STAFF RECOMMENDATION
2104 Grantland Avenue
May 21, 2014

Application: Demolition—outbuilding; New construction—outbuilding; Setback Determination

District: Woodland in Waverly Historic Preservation Zoning Overlay

Applicant: John Root, RootARCH

Figures 2, 3. The existing outbuilding is not easily visible and is not historically/architecturally significant.

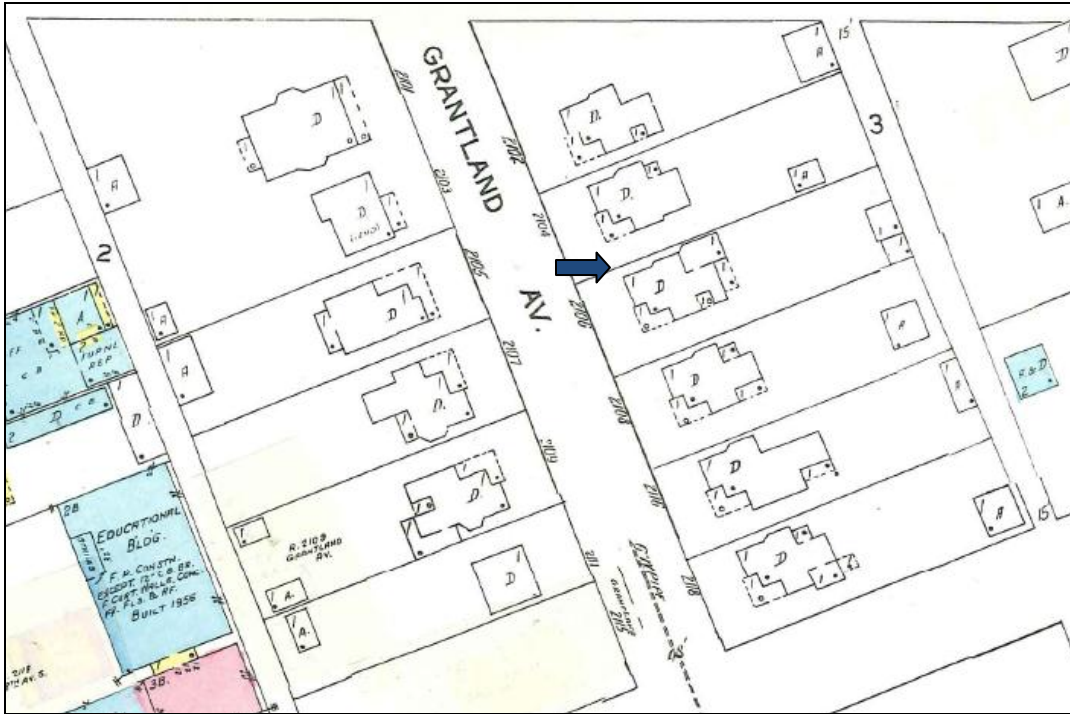
Demolition. The applicant is proposing to demolish a dilapidated shed at the rear of the property (Figures 2 & 3). The date of construction of the existing outbuilding is unknown, but it does not appear on a 1957 Sanborn Map (Figure 4). Staff finds that the structure does not contribute to this historic character of the site or to the Woodland in Waverly Historic Preservation Zoning Overlay. Staff therefore finds that the demolition of the existing outbuilding meets Section V.B.2. of the design guidelines for appropriate demolition and does not Section V.B.1. for inappropriate demolition.

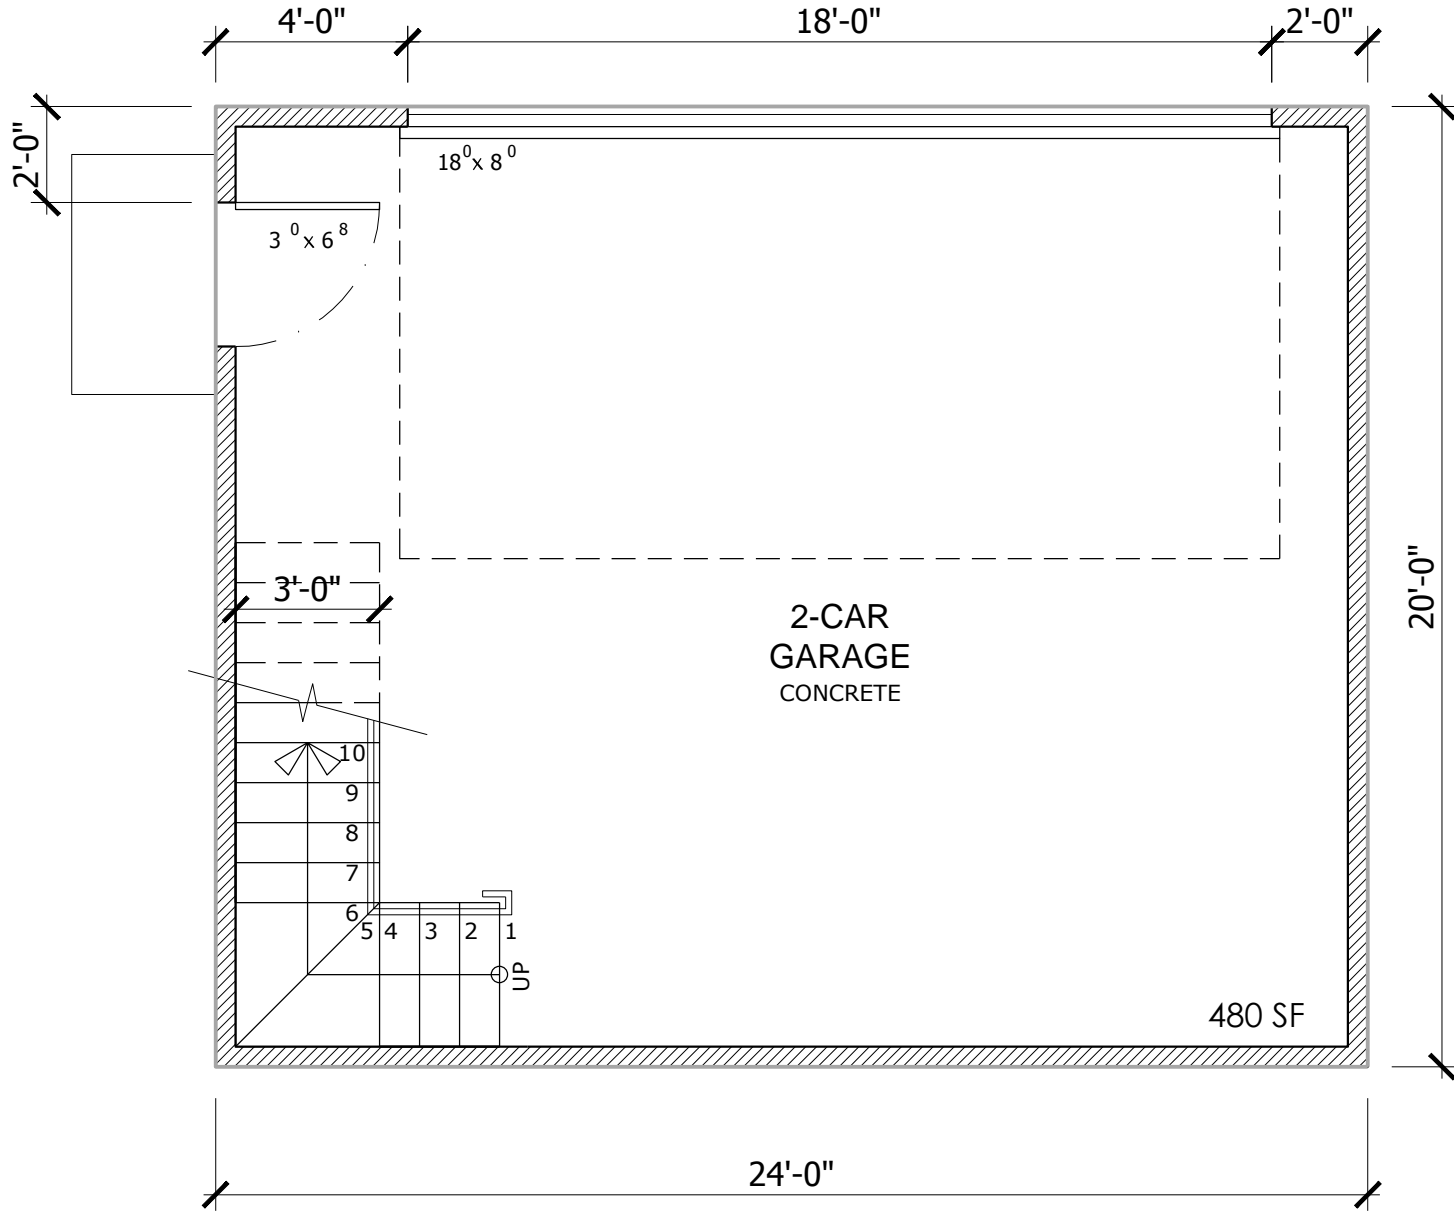
Staff finds that the proposed rear setback is appropriate because current Metro Map shows there are several existing outbuilding that are closer than ten feet (10') to the alley, and the 1957 Sanborn map shows that historically, many outbuildings were located near or on the rear property line (Figure 4). For these reasons, the Commission has approved many other requests for a five-foot (5') rear setback for buildings less than seven-hundred square feet (700 sq. ft.). Staff finds that the proposed location and the setback determination for the new outbuilding meet Section III.B.2.c. and III.B.2.h. of the design guidelines.

A1 ALLEY ELEVATION (FACING EAST)
SCALE: 1/4"=1'-0"

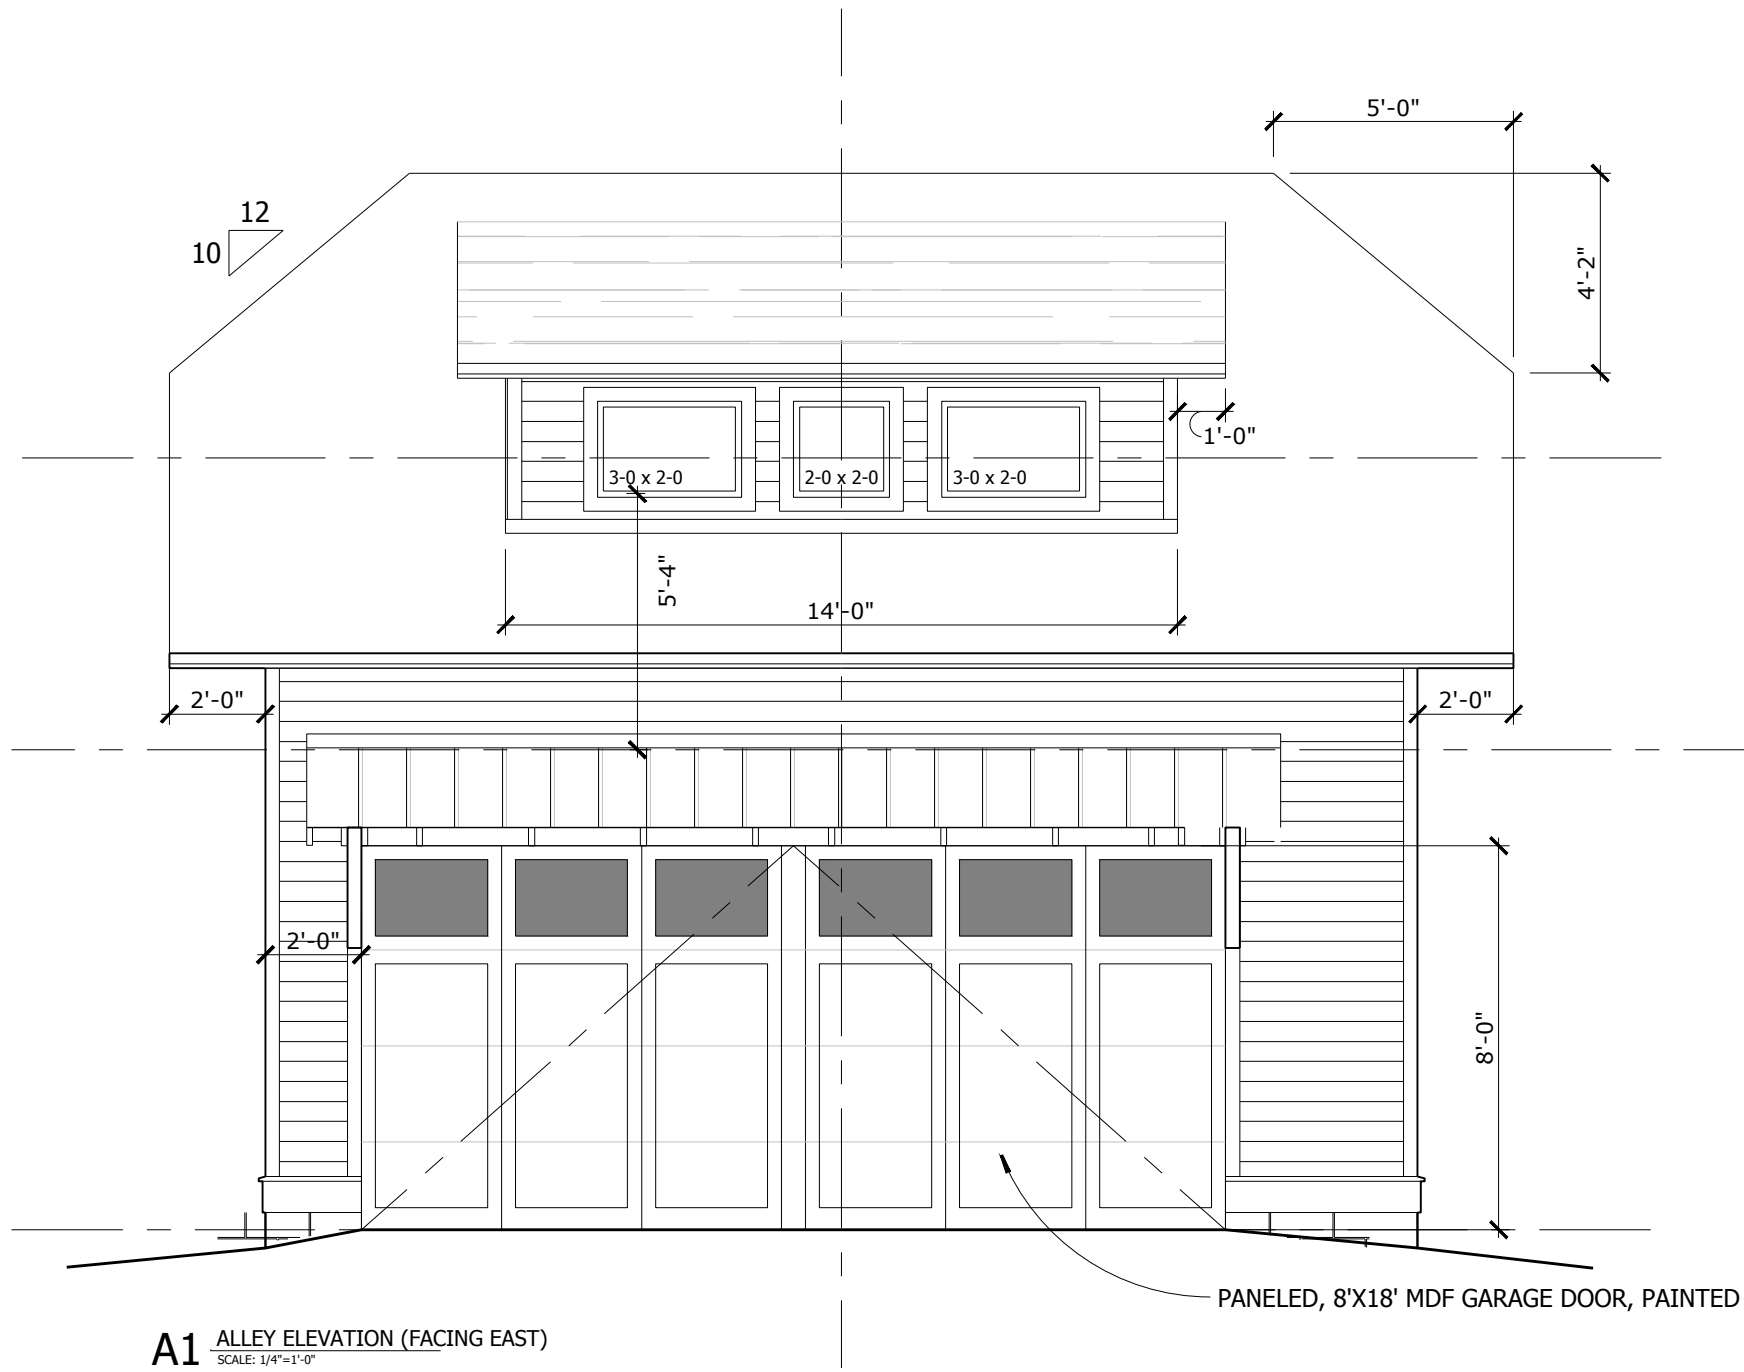
The proposed new outbuilding will be located at the rear of the property, and will be accessed via the alley, which is appropriate (Figure 5). The outbuilding does require a setback determination. Base zoning requires that the structure be three feet (3') from the side property lines and ten feet (10') from the rear property line. The outbuilding will meet the side setbacks, but will be located just five feet (5') from the rear property line.

Roof Shape: The outbuilding will have a clipped gable roof form with a slope of 10/12. The west and the alley elevations will have dormers with shed roofs with a slope of 4/12. Staff finds that the outbuilding's proposed roof shape meets Section III.B.2.e. and III.B.2.h. of the design guidelines.
